DUANE ARNOLD

SITE-SPECIFIC OFFSITE RADIOLOGICAL
PREPAREDNESS ALERT NOTIFICATION SYS
QUALITY ASSURANCE VERIFICATION

DUANE ARNOLD ENERGY CENTER
SITE-SPECIFIC OFFSITE RADIOLOGICAL EMERGENCY
PREPAREDNESS ALERT AND NOTIFICATION SYSTEM
QUALITY ASSURANCE VERIFICATION

September 14, 1989

FIGURE 2
DUANE ARNOLD ENERGY CENTER

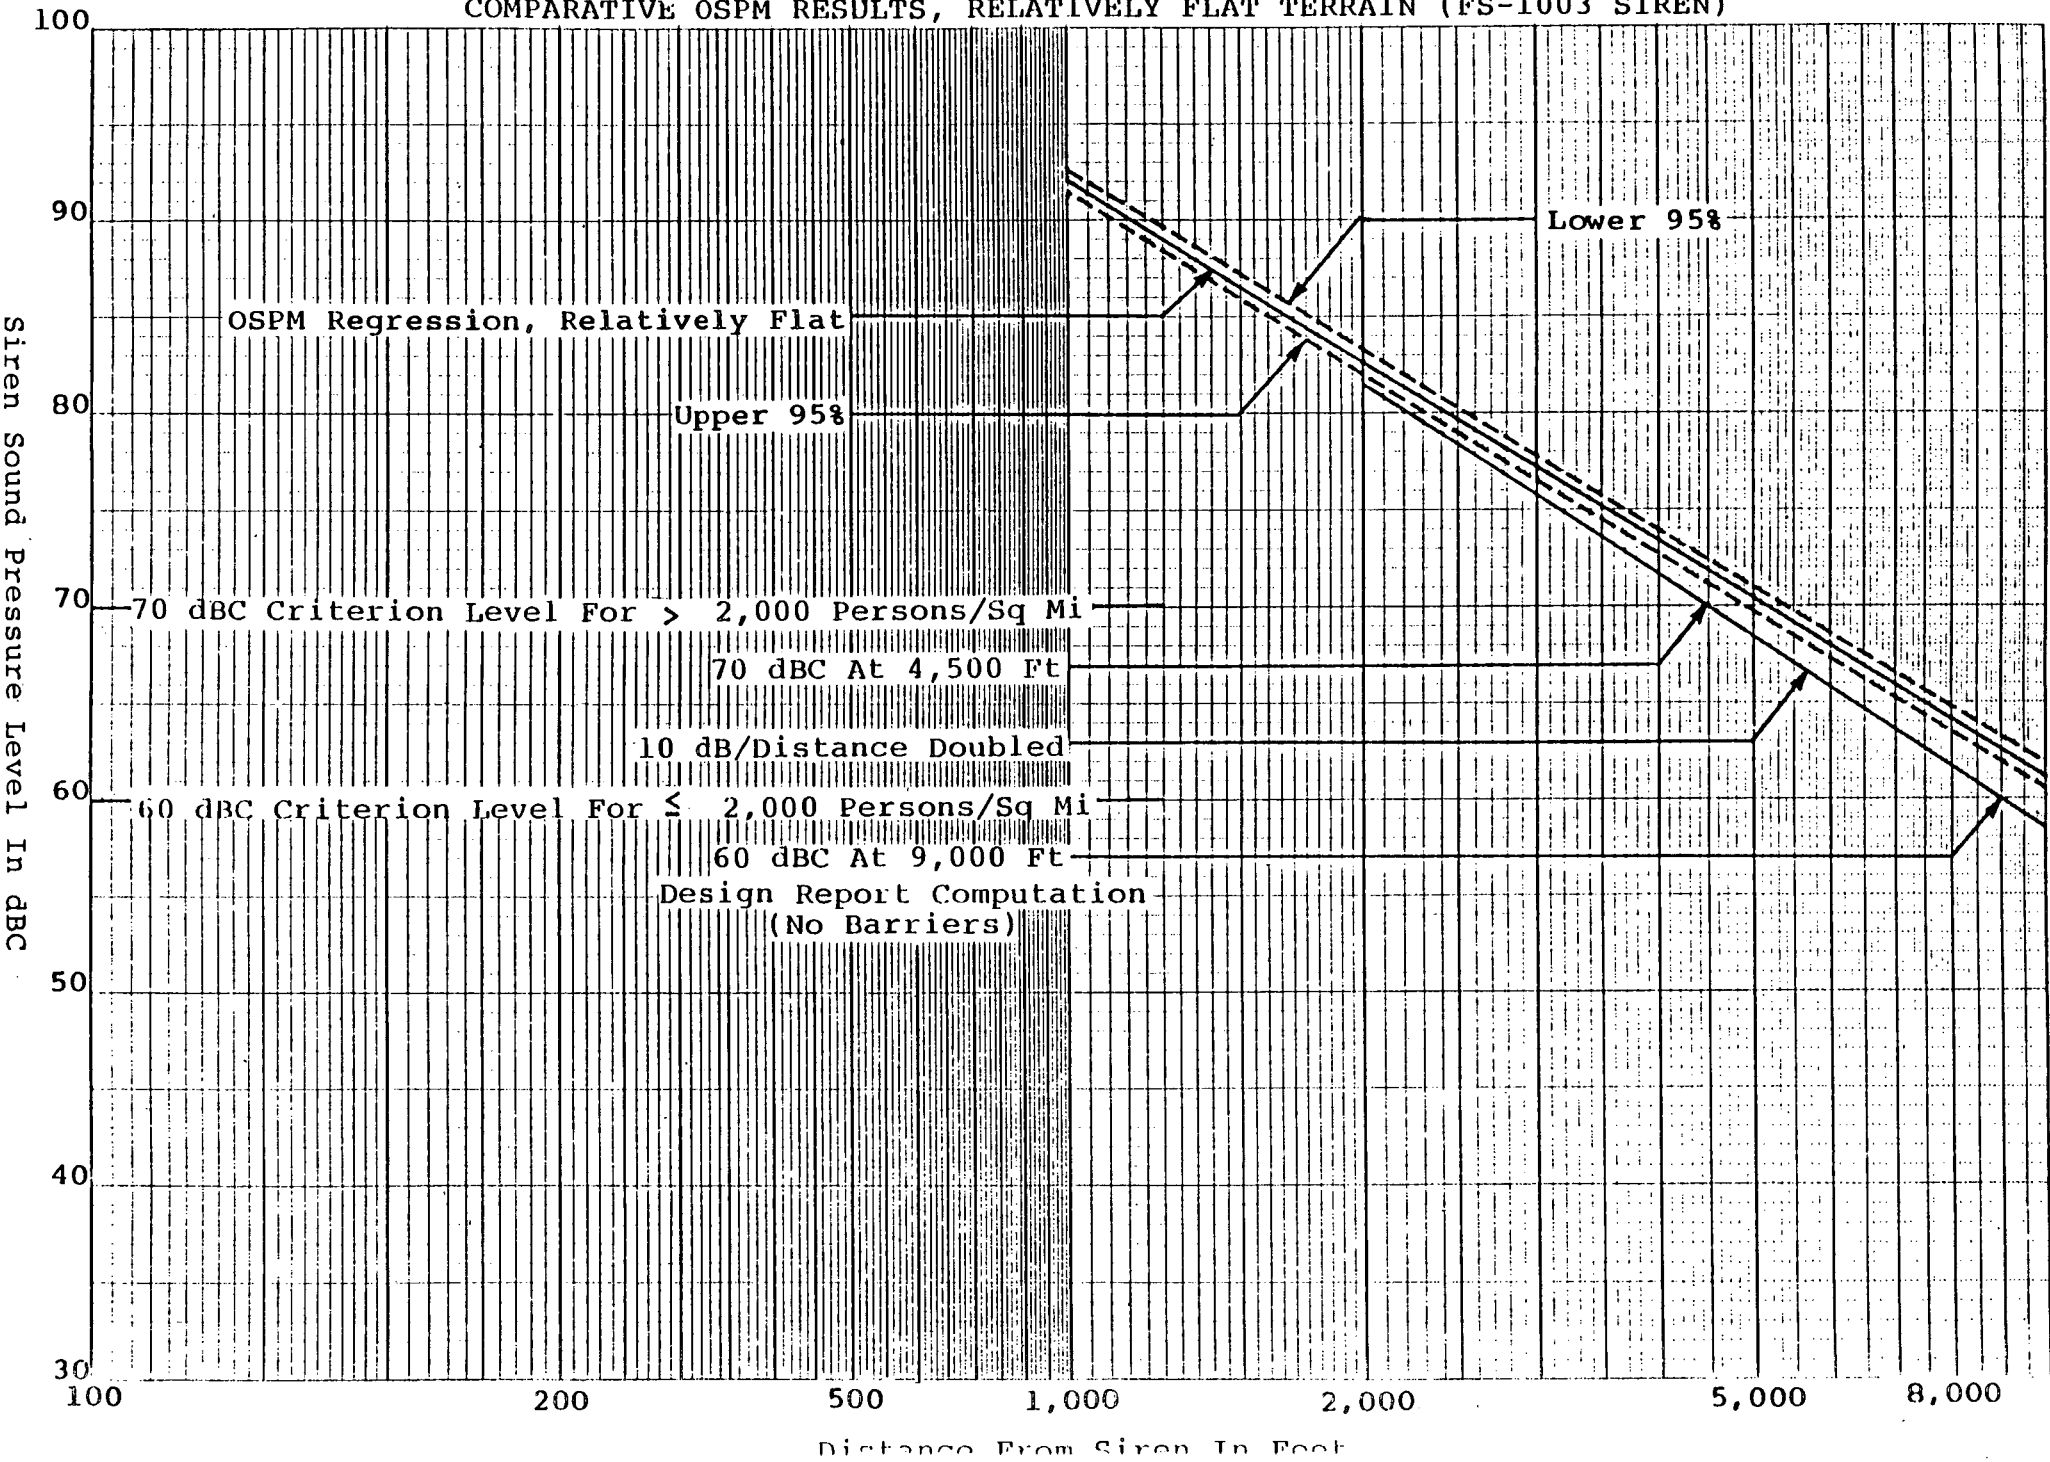
To assess the overall adequacy of the design on an area basis, for each siren located on the U.S. Geological Survey's Cedar Rapids North quadrangle map (Figure 2 of this report), the area coverages of 60 dBC and 70 dBC were numerically integrated and averaged. The results are as follows:

The results of the individual OSPM runs were combined to generate a comprehensive overview of the siren sound pressure levels in the Cedar Rapids North area as depicted in Figure 2 of this report. A surface interpolation and contouring program utilizing the output results of the 11 sirens was used to generate

the sound pressure level contours shown in Figure 2. These contours account for site-specific topographical and meteorological effects of the sirens.

Comparisons of the OSPM-predicted 60 dBC and 70 dBC contours with the contours in Appendix C of the Design Report indicate that the coverage of the sirens as calculated in the Design Report is liberal.

The original Design Report map showed the Cedar Rapids area containing more than 2,000 persons per square mile; however, the licensee's 70 dBC contours did not fully cover this area. The OSPM results confirmed that Cedar Rapids was not covered by a minimum siren sound pressure level of 70 dBC (see Figure 2 of this report).

licensee was asked to (1) ascertain that all geographical areas below 60 dBC coverage are either unpopulated or are exposed to actual siren sound pressure levels of greater than 60 dBC and (2) ascertain that the Cedar Rapids area containing more than 2,000 persons per square mile is fully covered by a minimum siren sound pressure level of 70 dBC, or (3) provide another primary alerting mechanism in those areas.

In response to the conditional approval, the licensee submitted a revised original Design Report proposing the use of 23 municipal civil defense sirens and 86 utility electronic sirens with public address capability. Also, the original design report was modified to include a revised EPZ (adding all of the Cedar Rapids and the Marion metropolitan areas). The revised installed siren warning system was analyzed and found to provide more complete and more uniform siren coverage throughout the modified EPZ. Appendix C of the revised Design Report identified some isolated areas within the EPZ with siren coverage slightly less than 60 dB(C). These areas were certified, in Appendix I of the revised Design Report, as being unpopulated.

In conclusion, the Duane Arnold Energy Center siren alerting system is found to meet the specific design requirements of FEMA-REP-10.
